SERVICE BULLETIN

SB-030525-B

ID NUMBER & REVISION: SB-030525-B
SUBJECT: Repair ELT GPS Connector Wiring
RELEASE DATE: 13 March 2025
EFFECTIVE DATE: 07 March 2025
SUPERSEDES NOTICE: SD-111324-A (upon completion of this Notice); SB-030525-A
 Note: *Completion of either SB-030525-A or SB-030525-B satisfies the required action.*

Figure 1. Incorrect Wiring (left), Correct Wiring (right)

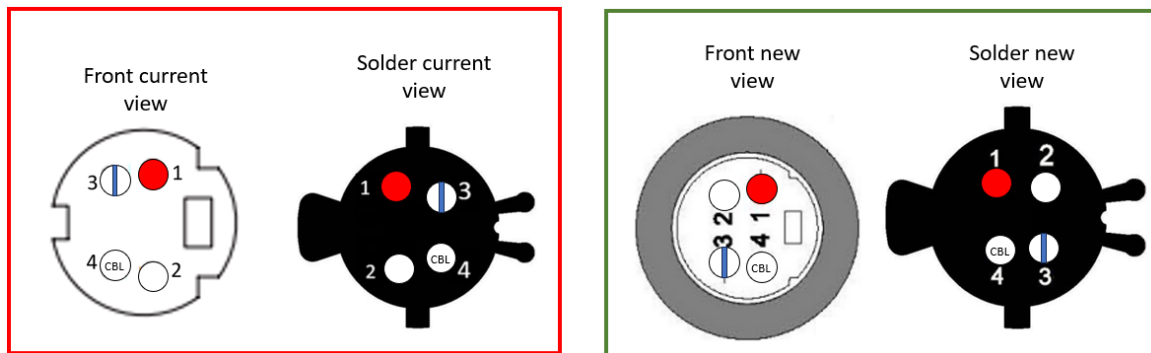
ICON has identified that the ELT GPS Connector, D9157P, may have been pinned incorrectly. This can drain the ELT battery, which may prevent the ELT from functioning. This may be recognized by a failed self-test, a red light flashing on the remote panel, and/or audible squelching from the overhead speaker.

SERVICE BULLETIN**SB-030525-B***Figure 2*

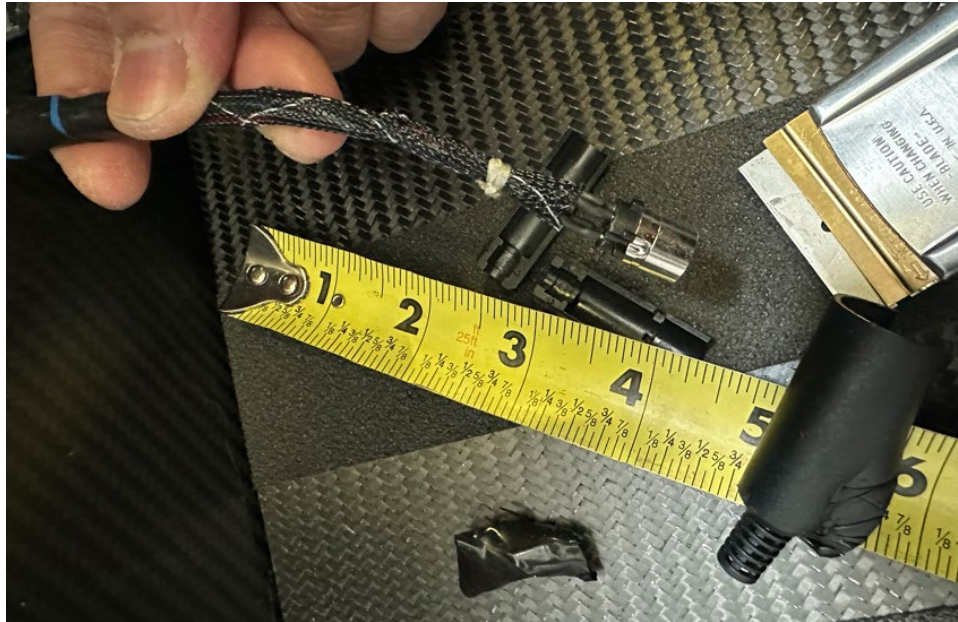
1. Access the ELT in accordance with the Aircraft Maintenance Manual, task 100293.
2. If desired, the Instrument Panel Top may also be removed in accordance with task 100514.
3. Remove the zip tie(s) securing the GPS connector, D9157P, to the harness.
4. Remove F4 tape from D9157P if necessary. For rework purposes, there should be a 4.5" tape clearance from the front of the connector to the test wire. (Figure 2)

Figure 7

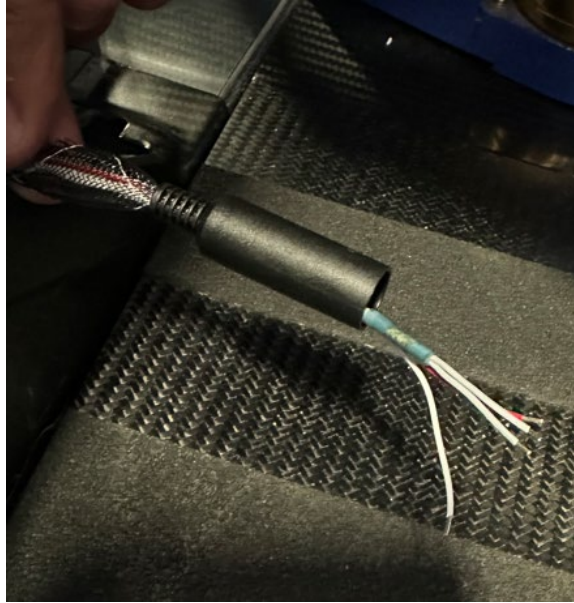
9. If removed, reapply connector label "D9157P".
10. Slide new connector plastic cover into the bundle back to where F4 tape is and identify which wires come from the multiconductor and which are single wires. (Figure 7)
 - a. You must have the following:
 - i. A two-conductor cable with a WH wire and a WH/BL stripe wire.
 - ii. RD single wire.
 - iii. WH single wire.

Figure 8

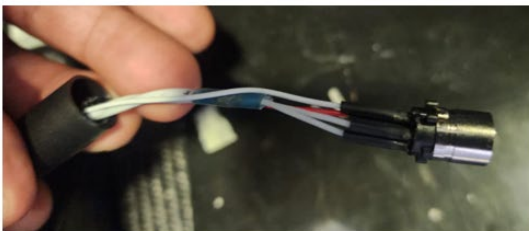
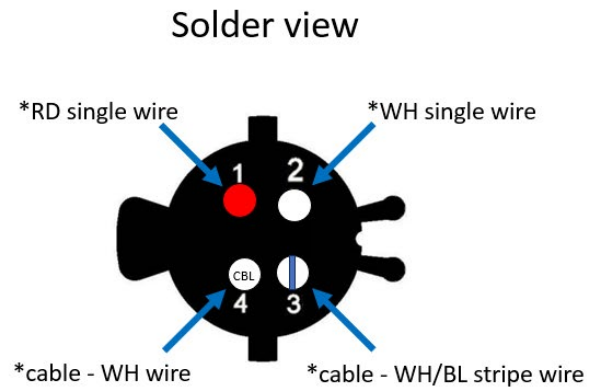
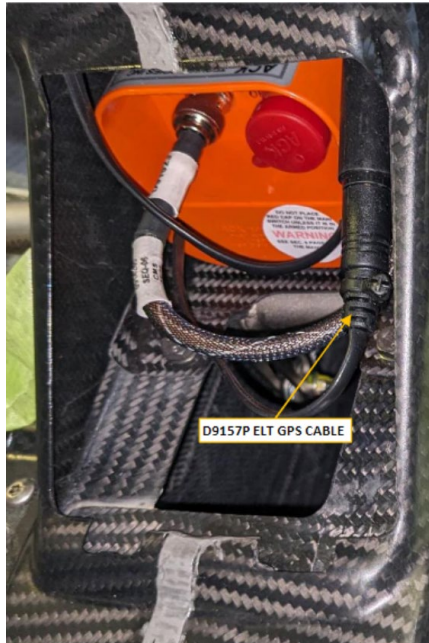
11. Strip wires 0.25" add a 1/16" heat shrink sleeve (0.5" long) per wire and solder as "Solder view" specifies below (Figure 8) with a lap solder. Then use a heat gun to shrink sleeves.

SERVICE BULLETIN**SB-030525-B***Figure 9*

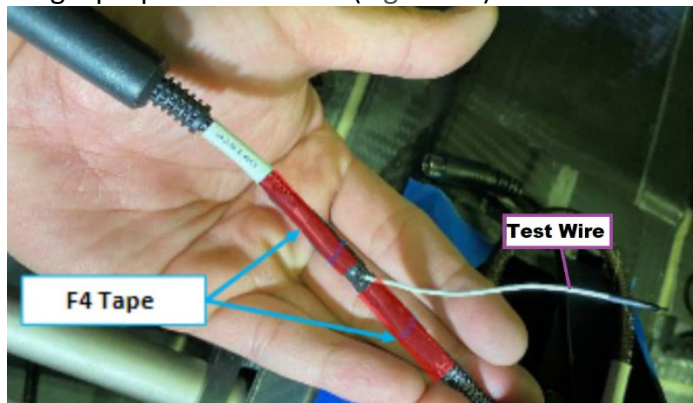
12. Assemble new connector body (two pieces). (Figure 9)
